Policy Newsletter

March 2026

Policy updates – major policy updates

CP411-2: HV jointing manual

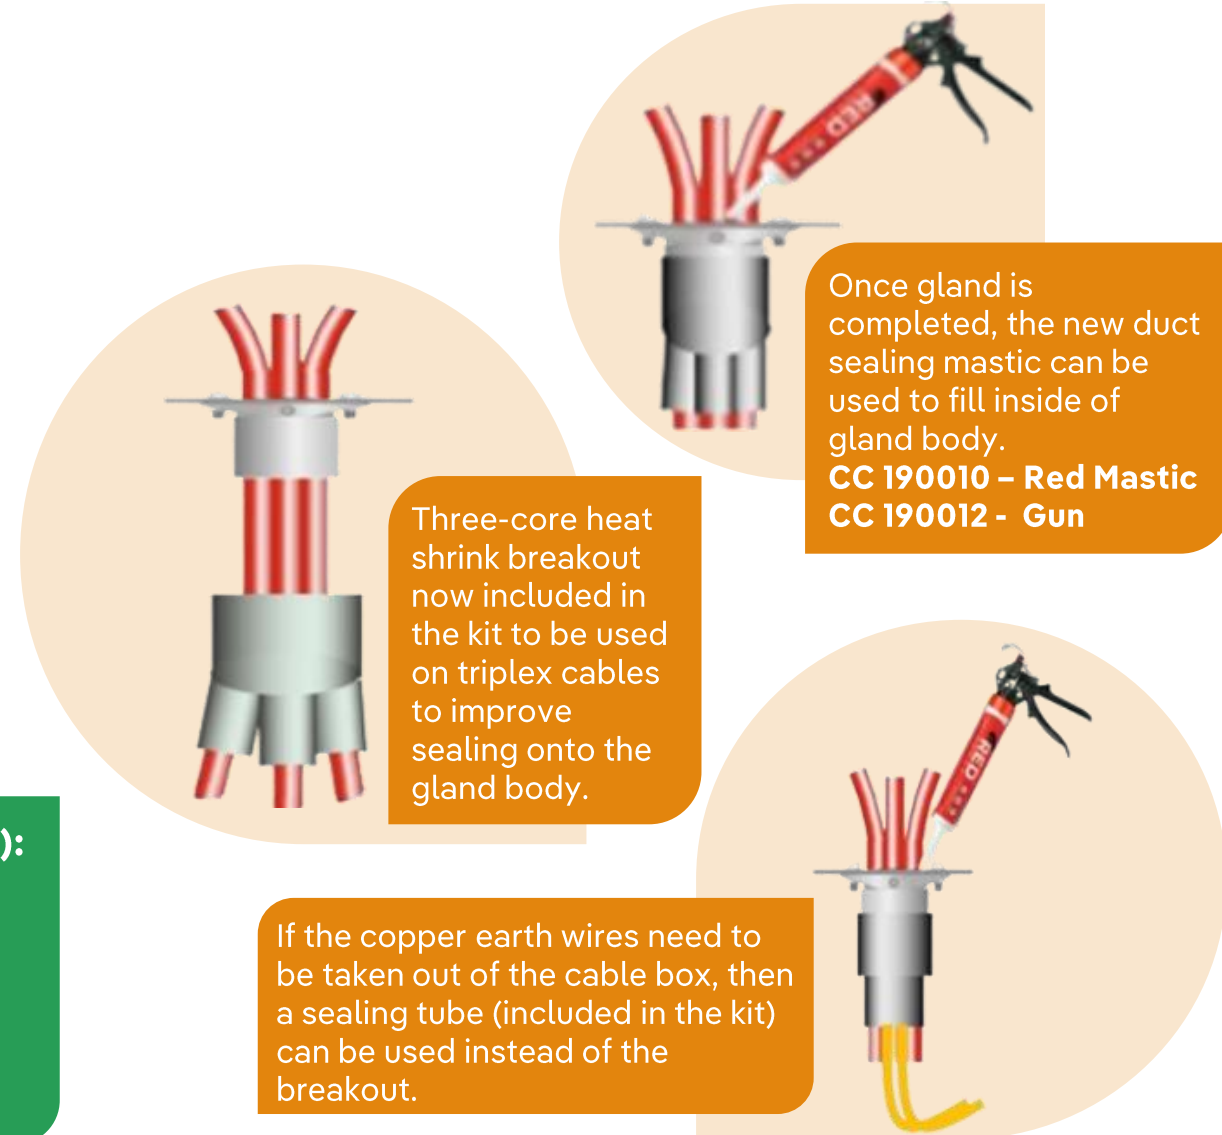
This update covers glanding of triplexed cables into cable boxes using “Bolted Top Hat Glands”.

- The supplier of the metal gland kits is now REPL.
- These kits now come with an additional, heat shrinkable, three-core breakout for sealing the triplex cables. For any arrangement where the cable earth screen wires need to be taken out of the box, a heat shrink tube is still supplied in the kit and can be used instead.
- Method to seal the small gap between the cables in a triplex arrangement updated to use the new duct sealing mastic, applied using the caulking gun.

- Section 2 – Standard Technique 42

Cable spacing

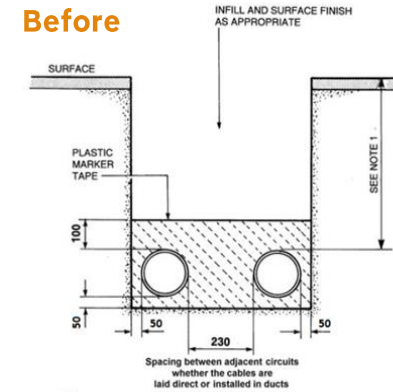
- Horizontal and vertical spacing between cables in multiple runs updated in line with industry standards – distance now measured from center-point of cable, instead of edge of cable/duct.
- Drawings and table updated to reflect these changes.
